1 Products affected

Product hierarchy no. *				Part no.	SBU	Product Type	Customer part no.
SBU	PG	PUG	Type				
02	006	016	0000001608	See list below	Power Entry Modules w/Filter	DG12	-

2 Type of change

Current product appearance	New product appearance with inlet gasket

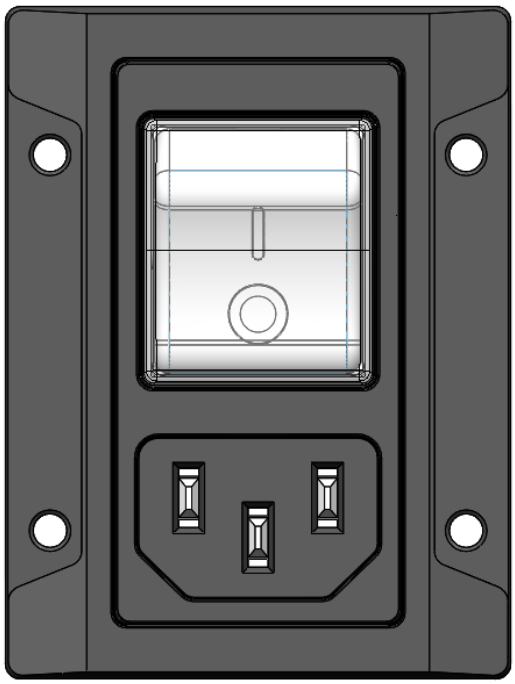
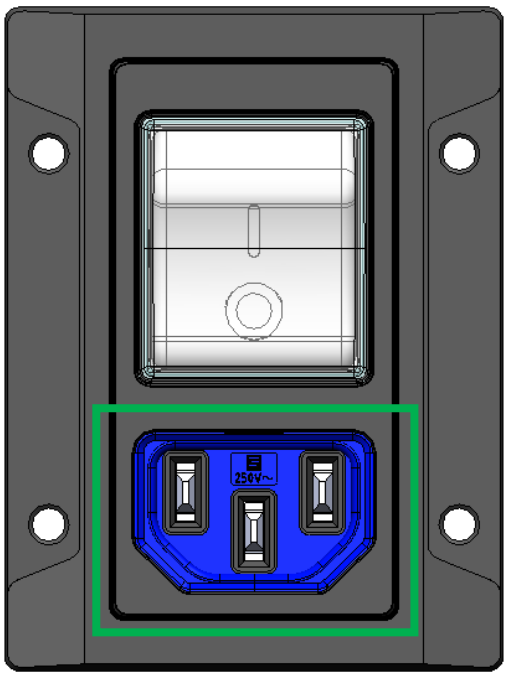
- Additional ingress protection against dust and/or liquids while connected for IP67 variants
- New inlet gasket for Ingress Protection of Power-connection
- Upgrade of Ingress Protection IP54 while connected with dedicated IP54 cordsets

- DG12, IP67 Variants towards housing fulfil new in addition IP54 against the power connection with dedicated IP54 cordsets
- This is done by assembling the blue Inlet Gasket as a standard

☒	Form	Inlet gasket integrated
☐	Fit	No
☒	Function	No action required, functionality with standard cordset unchanged
☐	Manufacturing	No
☐	Label	No
☐	Packaging	No
